MASTER DEVELOPMENT DRAINAGE PLAN AMENDMENT FOR STERLING RANCH

April 12, 2022
Project No. 25188.04

Prepared By:
JR Engineering, LLC
5475 Tech Center Drive
Colorado Springs, CO 80919
(303)-267-6240
Contact: Mike Bramlett, PE

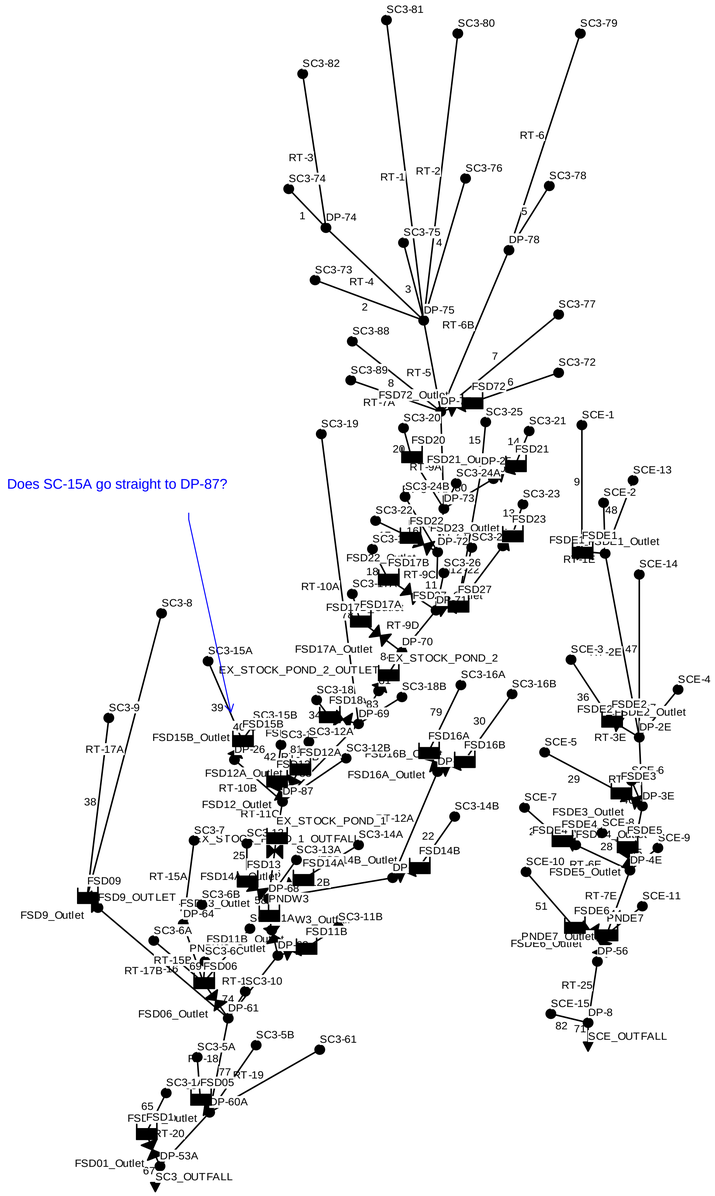
Does SC-15A go straight to DP-87?
SC3-81
SC3-80
SC3-79
SC3-82
RT-6
RT-3
SC3-74
RT-1
RT-2
SC3-76
SC3-78
1
DP-74
5
SC3-75
4
DP-78
SC3-73
RT-4
3
2
DP-75
SC3-77
RT-6B
SC3-88
SC3-89
RT-5
7
SC3-72
8
FSD72_Outlet
FSD72
6
RT-7A
DP-7
SC3-25
SC3-20
SC3-21
SCE-1
SC3-19
FSD20
15
14
FSD21
20
FSD21_Outlet
DP-2
RT-9A
SC3-24A
SCE-13
9
SC3-24B
DP-73
SCE-2
SC3-23
48
SC3-22A
12
FSD23
FSD22
FSD23_Outlet
SC3-22B
DP-72
FSDE1
FSDE1_Outlet
FSD22_Outlet
FSD17B
SC3-26
RT-1E
SCE-14
18
RT-9C
RT-10A
SC3-17
11
FSD27
FSD23_Outlet
DP-71
FSD17
FSD17A
RT-9D
SC3-8
DP-70
FSD17A_Outlet
8
EX_STOCK_POND_2
SCE-3
2E
47
SCE-4
SC3-15A
EX_STOCK_POND_2_OUTLET
SC3-16A
SC3-16B
SC3-18
SC3-18B
36
FSDE2
FSDE2_Outlet
SC3-9
39
SC3-15B
34
DP-69
DP-2E
FSD15B
FSD18
83
79
30
SC3-12A
FSD16A
FSD16B
RT-3E
FSD15B_Outlet
RT-17A
DP-26
42
SC3-12B
FSD12A
FSD16B_Outlet
DP-5
SCE-5
SCE-6
FSD12A_Outlet
FSD16A_Outlet
RT-10B
DP-87
29
RT-3
FSDE3
38
FSD12_Outlet
RT-11C
EX_STOCK_POND_1
RT-12A
SC3-14B
DP-3E
SCE-7
FSDE3_Outlet
SC3-7
EX_STOCK_POND_1_OUTFALL
SC3-14A
22
FSD14B
FSDE4
SCE-8
FSDE5
SCE-9
25
SC3-13A
